ADUR & WORTHING PLANNING SERVICES
PLAN AWDM/1352/16
DATE VALID Rec 28/10/16

FLOOR PLANS AND SECTIONS AS PROPOSED

PROJECT:
11 Feversham Close,
Shoreham by Sea
West Sussex

Scale/plan Size	DWG. NO.	P.J. Clay
1:100 At A3 1:50 at A1	2081/1 Rev A 24-10-16	August 2016

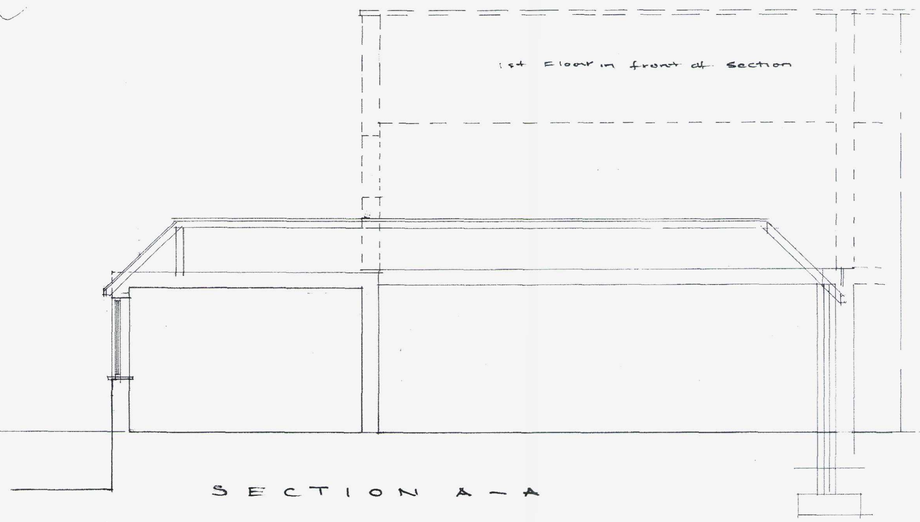
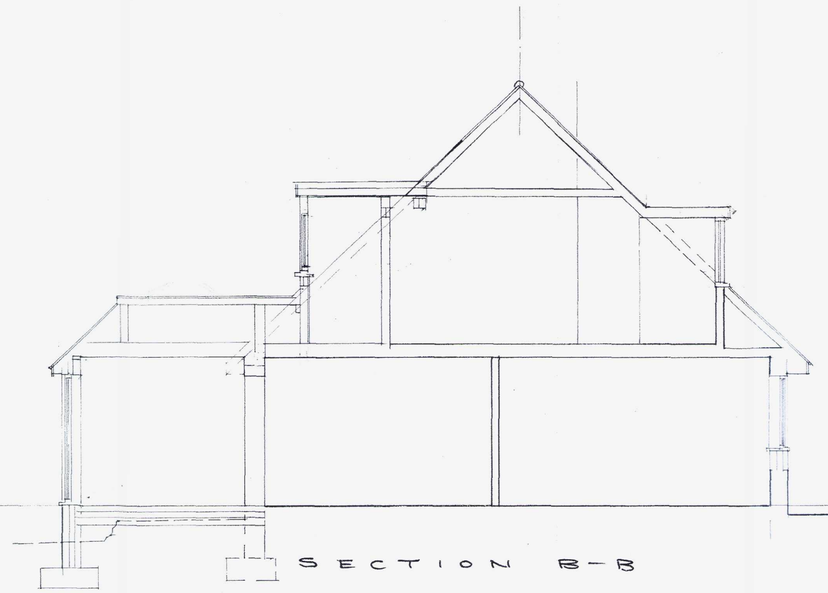
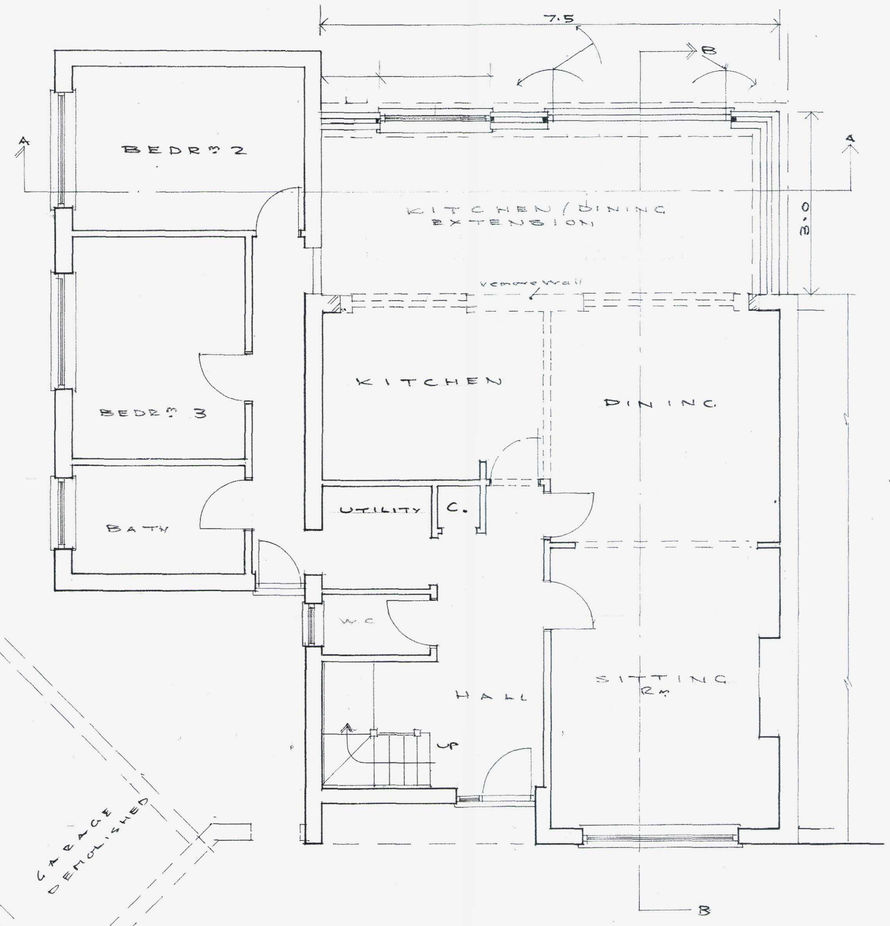
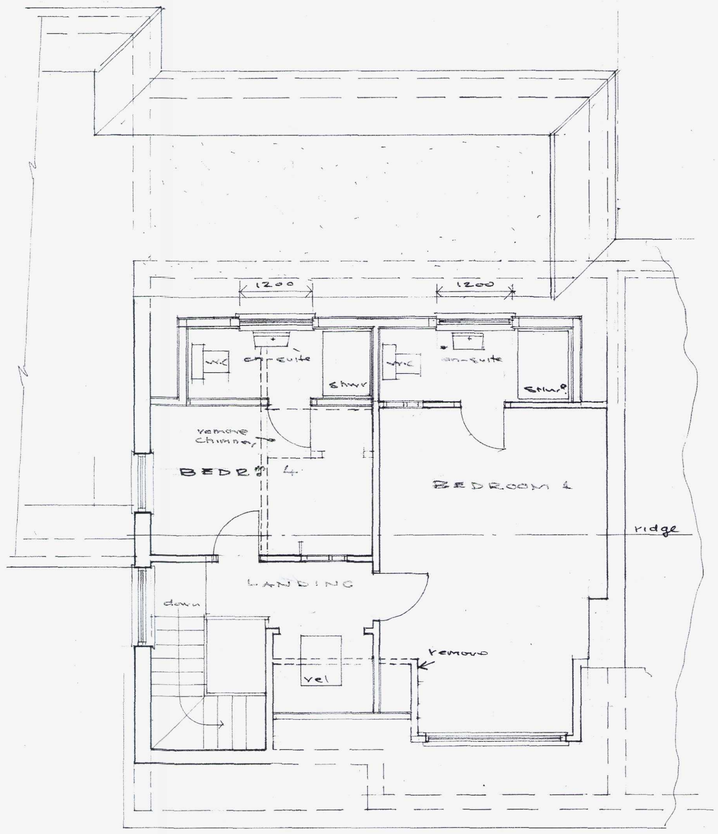
1. Tiled roofs to front and rear dormers omitted, front dormer retained as is, rear dormer with "flat" roof
2. Reduced window size to rear dormer, windows to be fully obscure glazed; top hung vents only openable, Fixed sash to remainder
3. Kitchen window repositioned
